WHITE OAK MINING AND CONSTRUCTION
JULY 28, 1998
ADDENDUM TO APPENDIX 742.310

Appendix 742.310
White Oak Mining and Construction July 28, 1998

CULVERT C-23-24 REMOVAL

ADDENDUM TO APPENDIX 742.310

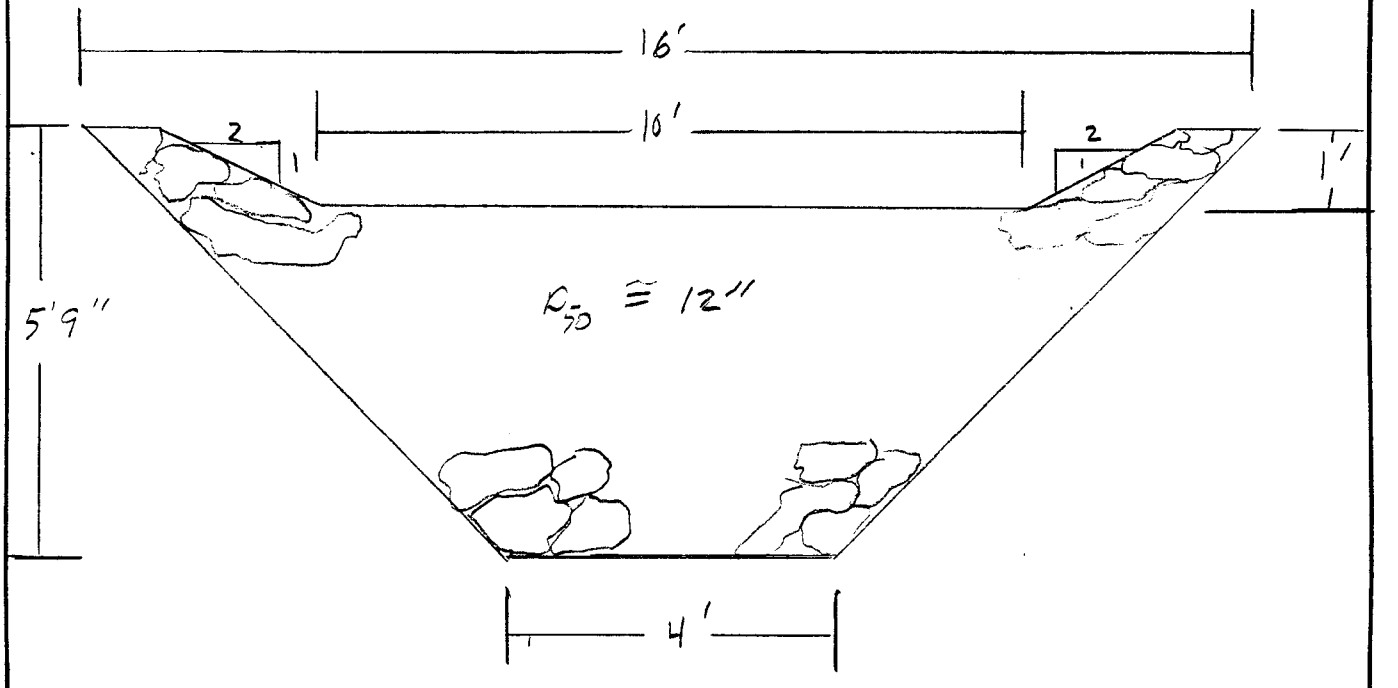
Check dam design (cont)

Spillway dimensions

BW = 10'
SS = 2:1
Depth = 1'

maximum flow depth = 0.13' (see pg 8)

maximum flow velocity = 3.31' (see pg 9)

Required riprap D_{50} = 3" < 12" ok (pg 10)

minimum freeboard = 1' − 0.13' = 0.87' ok
